PCN #: 2381

PCN Title: Qualification of Additional FAB & A/T Source, and/or Bill of Materials (BOM) for Select Products

PRODUCT CHANGE NOTICE**PCN-2381 REV 1**

Table 3A
Current SOT23R POD

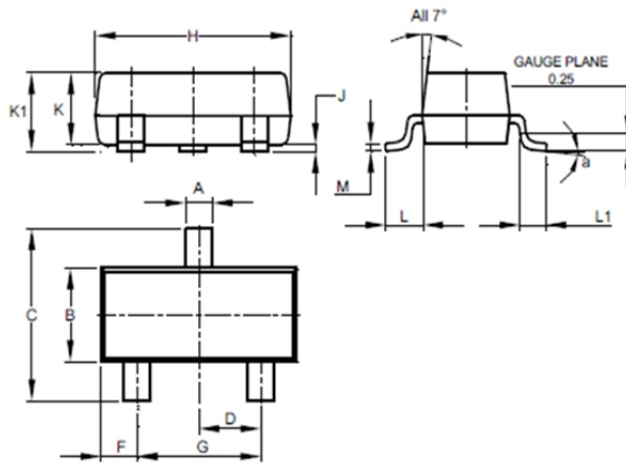
IMPACT				
No change in datasheet electrical parameters however, some devices will have different package outline dimensions (POD) as noted in Table 3A below.				
PRODUCTS AFFECTED				
Table 1 - Qualify Additional FAB Source (SFAB2) for MOSFET Device, and BOM (Die Attach Epoxy, and Mold Compound) Table 2 - Qualify Additional BOM (Lead Frame, Die Attach Epoxy, and Mold Compound) Table 3 - Qualify Additional A/T Site (SAT) , BOM, and New POD (Table 3A) Table 4 - Qualify Additional BOM (Die Attach Epoxy)				
WEB LINKS				
Manufacturer's Notice:	https://www.diodes.com/quality/product-change-notices/diodes-product-change-notices/			
For More Information Contact:	http://www.diodes.com/contacts.html			
Data Sheet:	http://www.diodes.com/catalog			
DISCLAIMER				
Unless a Diodes Incorporated Sales representative is contacted in writing within 30 days of the posting of this notice, all changes described in this announcement are considered approved.
